75 Lawn Road, London, NW3 2XB  
Application Ref. (2018/2136/P)

## RESPONSE TO CONSULTEE COMMENTS

September 2018

Diagram showing increase in footprint by proposed development

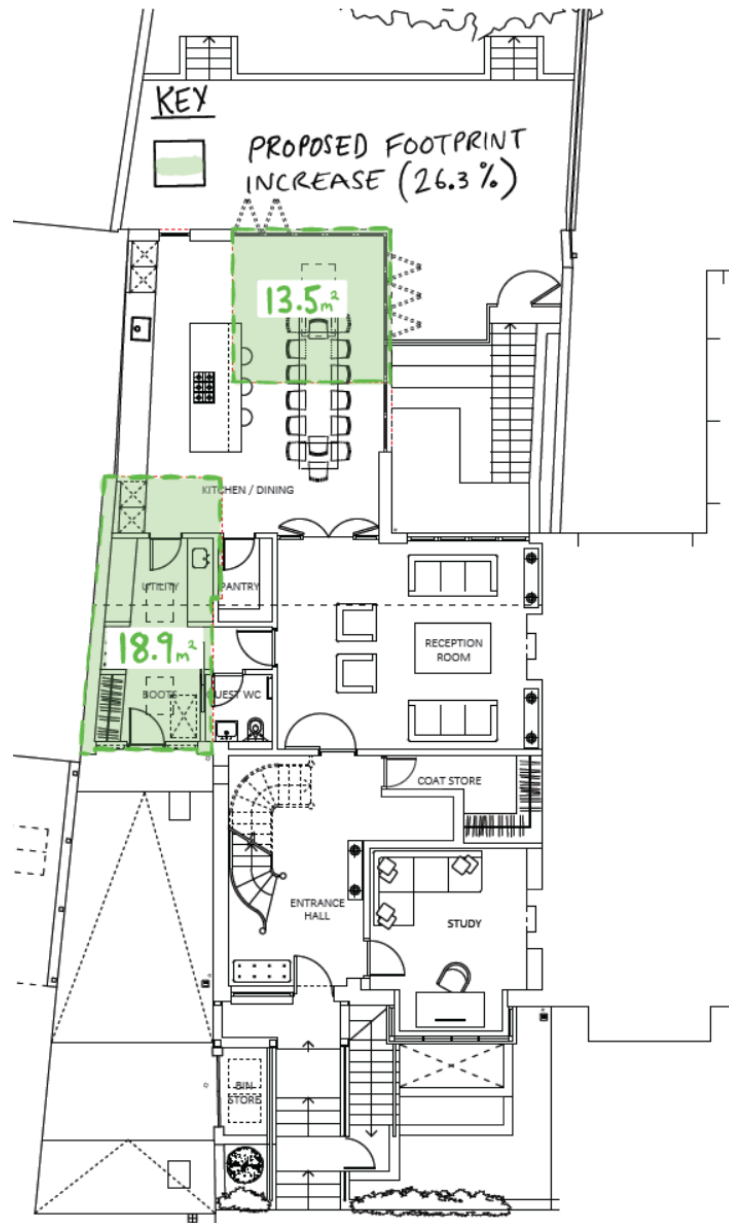
The CAAC have objected to the 'hugely over-developed scheme', whilst the Belsize Residents Association have commented that it is an 'overdevelopment of the site' and 'near doubling of the existing property'.

- 4.1. FOOTPRINT - The increase in property size has been significantly overstated. The proposed percentage increase in the overall footprint (GEA) of the property is approximately 26.3%
- 4.2. BASEMENT GIA - The area of the proposed basement at No.75 Lawn road is 124m<sup>2</sup> (GIA). This is substantially smaller than the recently approved basement development at No. 77 Lawn Road (2016/1737/P) which has an area of 183m<sup>2</sup> (GIA) - based upon application drawings. The size of the proposed basement development is therefore in keeping with established precedents along the street.

*Section showing screening of the front lightwell by vegetation and height of existing front wall*

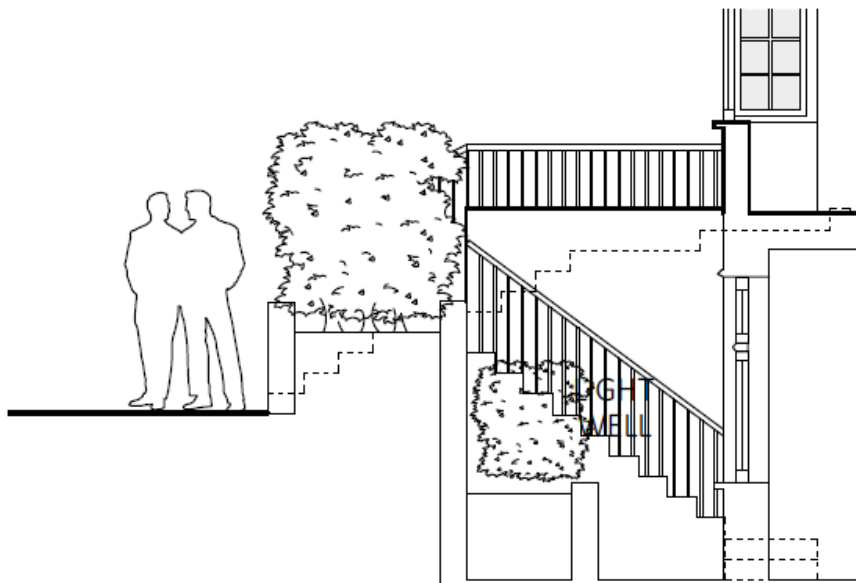
- the size of the front and rear lightwells, stating they will 'disturb both the front and rear gardens';
- the visibility of the front lightwell and access steps to the street, stating that it will be 'clearly visible, from the street';
- the proposed 'set back' distance between the rear lightwell and boundary wall of No.74/75.

5.3. The front lightwell and access stair will be well concealed behind soft landscaping, and sits at a higher level to both the pedestrian pathway and road. This element will therefore not impact

the street scene and the character of the Conservation Area since it is not visible from the public realm - as shown in the visualisation and section below.

Plan at first floor showing 45-degree visibility zone from first floor of no. 76 Lawn Road.

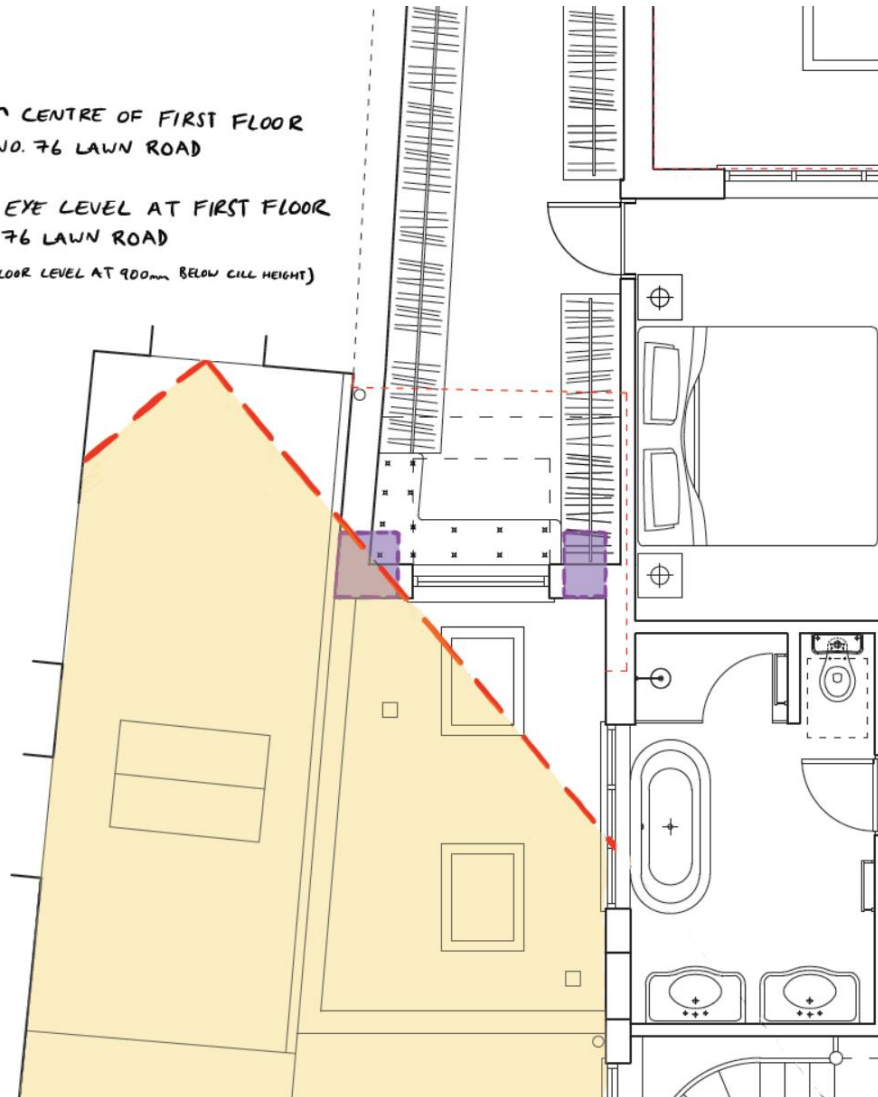
The neighbours at Nos. 74 & 76 Lawn Road have objected to the proposed first floor front/side extension claiming it will be 'over-bearing and create a sense of enclosure', with the resident at No.76 adding that the new 2 metre projection 'will create a tunnel effect'.

Applying the 45 degree line rule of thumb to the first floor window above the garage of No.76 shows that the 45 degree splay does bisect the proposed front extension to No.75 Lawn Road. However, due to its sloped form, this area is almost entirely below eye level (1600mm) as viewed from the first floor level of no. 76 (see sketch below). It is therefore considered that there will be a negligible impact upon No.76's amenity in terms of sense of enclosure.

Extract of proposed rear ground floor extension to No.75 Lawn Road

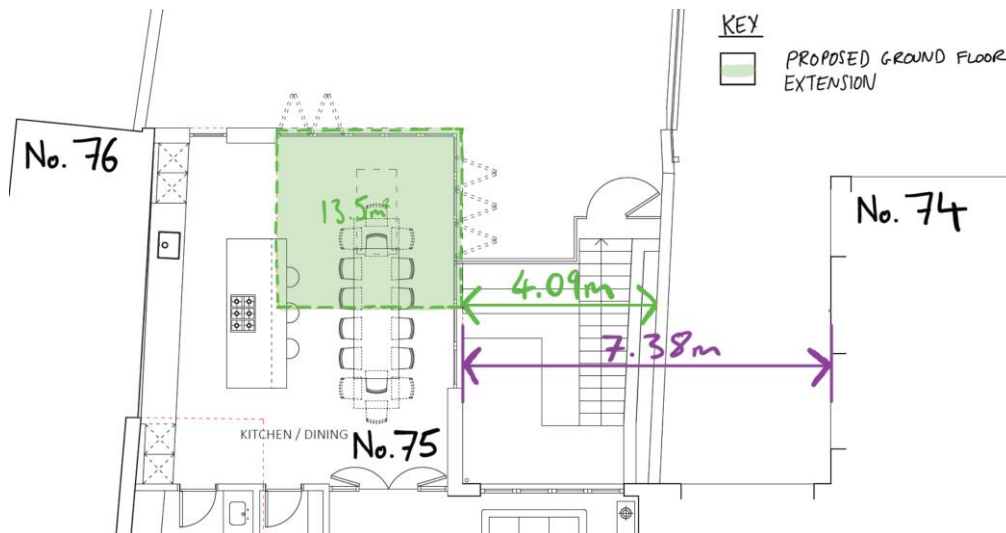
- 'Object to the height of glazing in the new ground floor windows facing' No.74, 'if this is greater than the level of the top of the glass panes permitted at 79 Lawn Road i.e. approx. 2600mm.'
- The parapet height of the ground floor rear extension should be no greater than the height of the ground floor extension at No. 79 Lawn Road (2016/0313/P) as approved which is '3150mm'.
- Gutter level and parapet wall of rear first floor rebuilt garage block above dressing room should match the existing.

- 8.3. The parapet for the ground floor rear extension is 3300mm. According to CPG1, 4.12 *'In order for new extensions to be subordinate to the original building, their heights should respect the existing pattern of rear extensions, where they exist', and 'In cases where a higher extension is appropriate, a smaller footprint will generally be preferable to compensate for any increase in visual mass and bulk.'* The proposed extension is not visible from the street and there is no consistent rhythm or pattern across the existing rear extensions.
